TO: CC
THRU: CH *MSM*
FROM: HD *HD*
SUBJECT: Value Engineering Proposal
Federal Project ACBI-0025(091)
State Project S320-P25-0.05 00
Dick Henderson Bridge
Kanawha County

Re: Dick Henderson Bridge
State No. S320-P25-0.05 00
Federal Project No.: ACBR-0025 (091) TC
Kanawha County, West Virginia
Value Engineering Proposal – MSE Walls

Kokosing Construction would like to formally present a Value Engineering Proposal (VEP) for the Dick Henderson Bridge Project. We propose to provide ground improvements under the MSE Wall approaches which would allow the construction of a traditional MSE Wall with granular backfill. This would replace the Expanded Polystyrene Fill (EPS) without reducing design capacity and will provide a quality final product while reducing long term risk and maintenance. Additional significant benefits to the project are outlined below.

TYPICAL SECTION AT ABUTMENTS

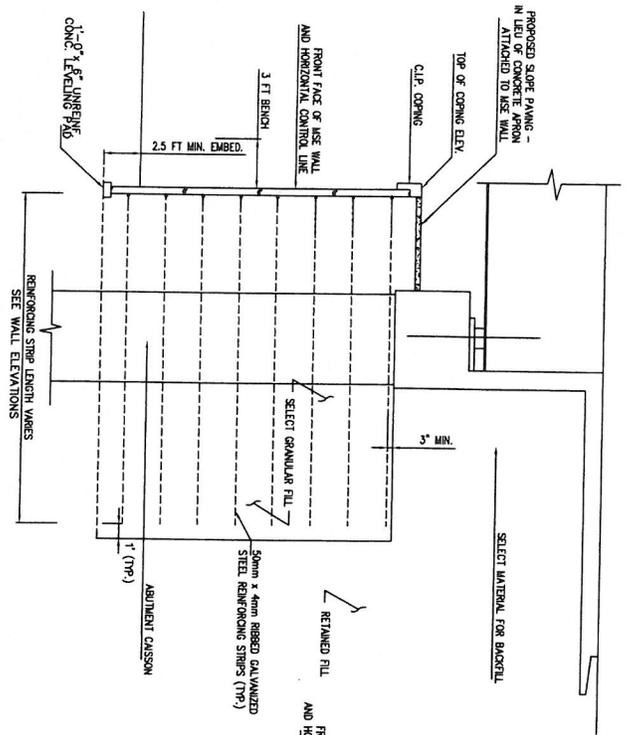
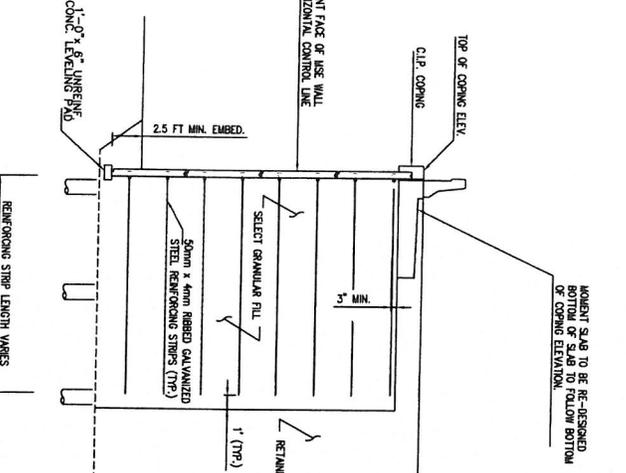
Once the underlying soil is reinforced using the CMCs, a conventional MSE wall will be constructed using standard Select Granular Backfill. The EPS fill, specialized connections, and unitstruts will be eliminated. The use of ground improvements will allow for a shallower excavated area along the approach roadway. The moment slab as detailed on contract plan sheets 155 thru 158 will be raised to just below pavement level and constructed as a conventional pavement section.

- a. Unistrut connections from abutments to concrete apron as shown on sheets 84 & 89/281 would not be constructed
- b. All references to EPS Backfill would be disregarded
- c. MSE typical section as shown on sheet 155/281 would be modified to reflect standard construction with Select Granular Backfill
 - i. 8" granular leveling pad would be replaced with a granular load transfer platform as designed by Menard Ground Improvement Specialists
 - ii. Select Granular Backfill would replace the EPS Backfill in the reinforced zone with retained fill outside of the reinforced zones
 - iii. A conventional MSE panel to reinforcement strip connection would be used
 - iv. 6" load distribution reinforced slab would be eliminated
 - v. Thickened Aggregate Base Course material on top of load distribution slab would be eliminated
